Amendments to the Drawing:

Attachment: New Sheet of Drawing

Fig. 3

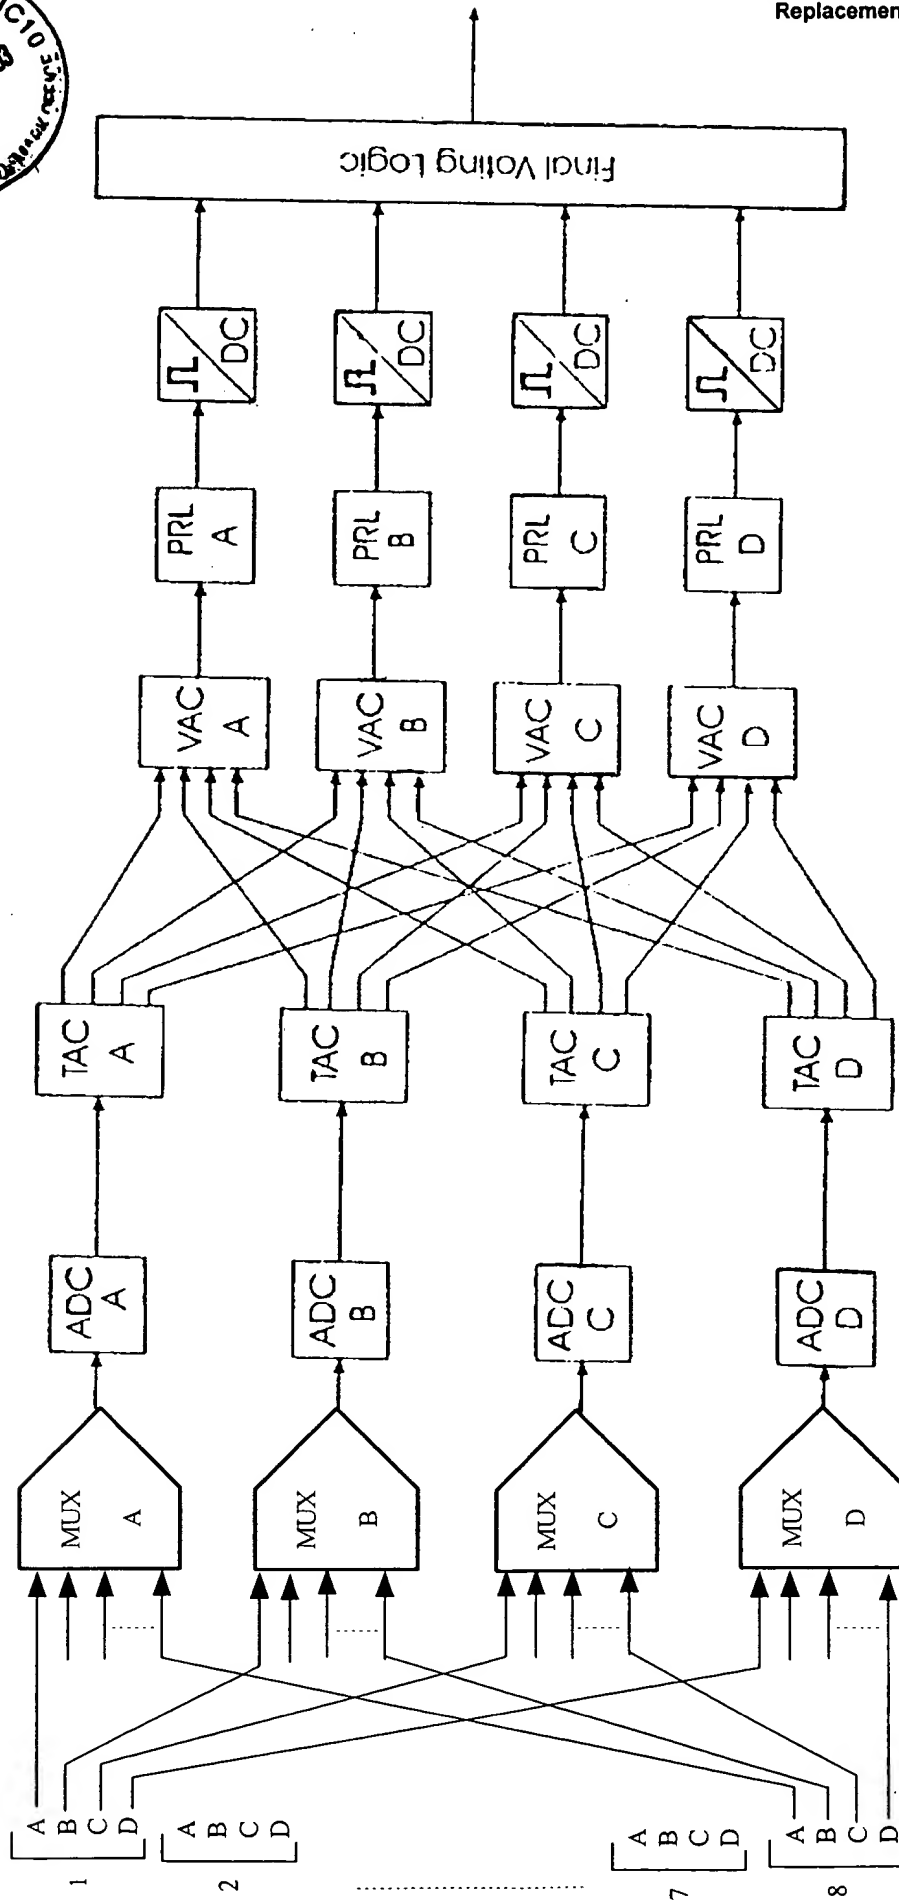
The attached sheet of drawing includes new Fig. 3, labeled "PRIOR ART". Support for Fig. 3 can be found in Fig. 2, column 3 with respect to a "DSS" system and as described in the Specification as a "conventional dynamic safety system (DSS) that has four independent measuring channels." Accordingly, no new matter is added by the addition of Fig. 3.
